PIC16C72A Rev. A Silicon Errata Sheet

The PIC16C72A (Rev. A) parts you have received conform functionally to the Device Data Sheet (DS35008A), except for the anomalies described below.

FIGURE 1: $\overline{\text{MCLR}}$ EXTERNAL CIRCUIT

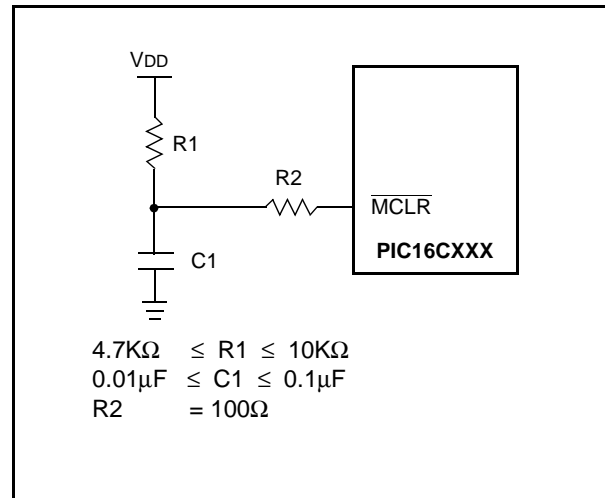
The minimum specification for the $\overline{\text{MCLR}}$ must be met in order to RESET the PIC16CXXX. If a $\overline{\text{MCLR}}$ pulse occurs that is less than the minimum specification (parameter #30), improper device operation can occur.

If the minimum specification cannot be met, then an external circuit must be used to insure that any pulse width less than the specification will be filtered before it reaches the $\overline{\text{MCLR}}$ pin.

A possible circuit is shown in Figure 1. Proper design validation needs to be done to ensure desired operation over the applications operating conditions

Figure 1: Wake-up from Sleep

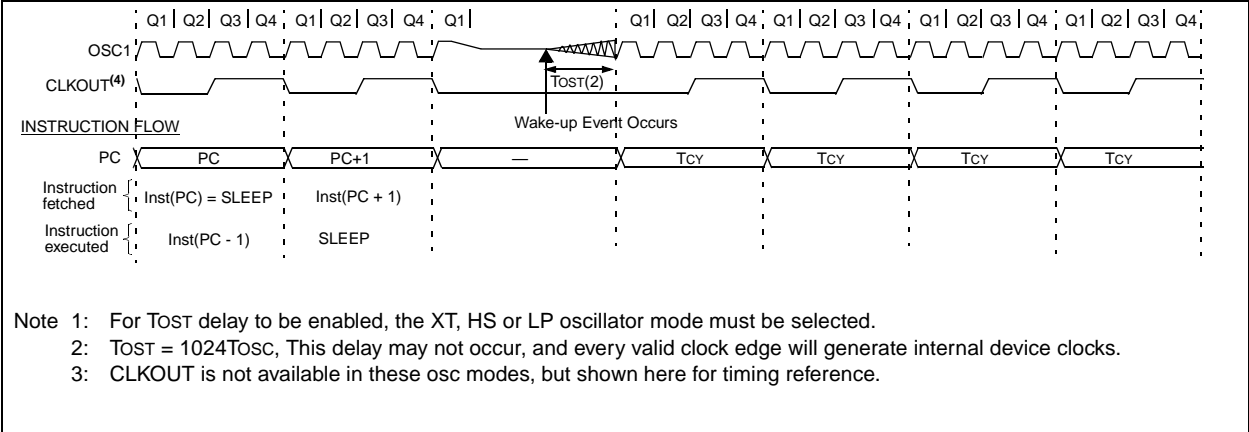
The Oscillator Start-up Timer (TOST) delay may not occur when the device wakes-up from sleep.

Figure 1 shows the start-up of the crystal after the event that causes the device to wake up from sleep mode (as specified in device data sheet). The start-up time (TOST) may not occur.

After the SLEEP instruction, do a software delay of 256 Tcy (same as 1024 TOSC). At the Reset and Interrupt vector addresses, test to see if the device woke from sleep (the $\overline{\text{TO}}$ and $\overline{\text{PD}}$ bits), and if the device did wake from sleep, ensure that the total cycle delay is 256 Tcy.
